To: Investments and Loans Pty Ltd
Project: 762 Pittwater Road, Brookvale
Report: BCA Assessment Report
Reference No: 107632 -BCA-r1
Date: 29 May 2019
Client Contact: Paul O'Keefe
Email: paul@okeefe architects.com.au
From: Ben Long
Direct: 8484 4009
Email: blong@bcalogic.com.au

1 BASIS OF ASSESSMENT

1.1 Location and Description

5.6 Discharge from Exits – Clause C1.10

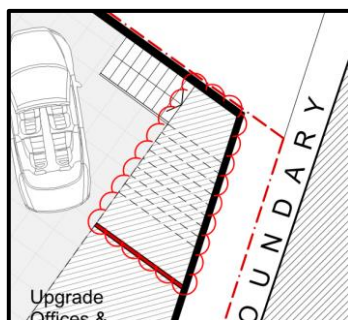
The exits both discharge onto the vehicular access, which will allow for the possibility that cars may block the point of discharge.

1. Bollards must be provided to each of the exit points to ensure a 1000mm clear egress width is maintained.

5.9 Access to Buildings – Clause D3.2

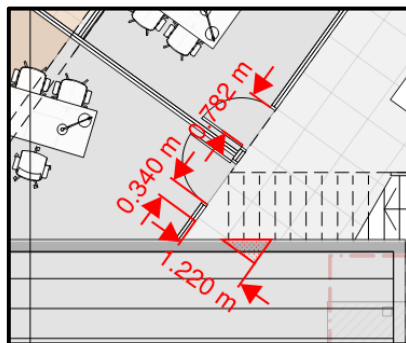
Access to the building is subject to discussions with the Architect as to the proposed method of gaining access from the footpath into the building.

It is considered that a Performance Solution to allow access into the building from the Delivery Room would not be possible to achieve, as this would additionally create an issue of less than 50% of the entrances would be accessible.

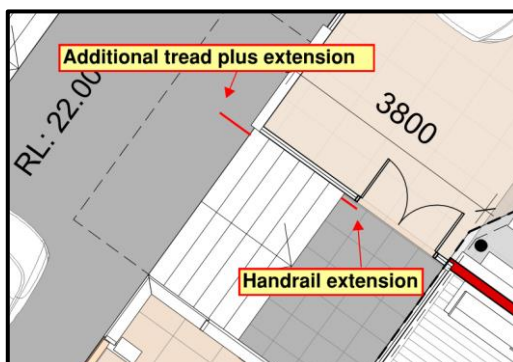
Each of the new stairways are required to be provided with two handrails, handrail extensions and tactile indicators in accordance with AS1428.1-2009. This will have an impact on the central entrance stair as the extensions will impact with the door operation and protrude into the vehicle access.

1. It would be recommended to offset the stair within the building to not have the handrail protruding into the vehicle access; and
2. Provide a door entry that is clear of any handrail extensions.

5.11 Lift Landings – Clause E3.5

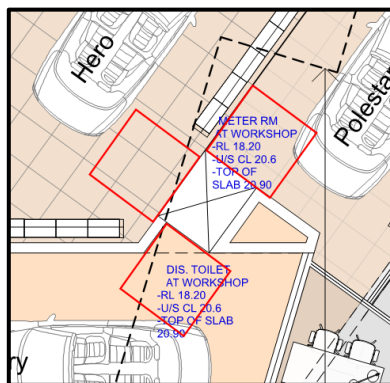
A low riser Low speed Constant Pressure Lift has been proposed to provide access throughout the different levels of the building. It is required that each of the landings are provided with sufficient turning space to allow for access to and from the lift.

The current landings are not considered to be suitable due to the location of the cars throughout, although this may be altered at any time it is considered that where a 90 degree turn is required at either landing a space up to 1500mmx1500mm is made available in accordance with AS1428.1-2009.

5.12 Passenger Lifts – Clause E3.6

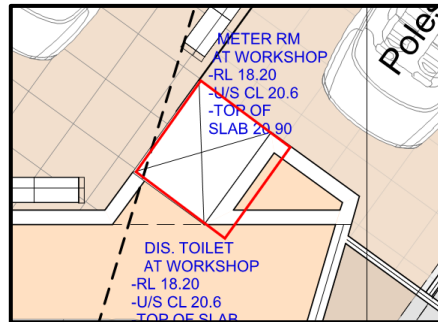
The proposed lift currently connects three different floor levels all with different angles of entrance, this would therefore require the occupant to turn whilst in the lift to allow for them to egress the lift in the appropriate direction. The current lift dimensions would not allow for turning and therefore not allow for suitable access to each of the levels.

1. It would be required that the lift provide an internal clearance of 1500mm x 1500mm to allow for suitable turning in accordance with AS1428.1-2009.
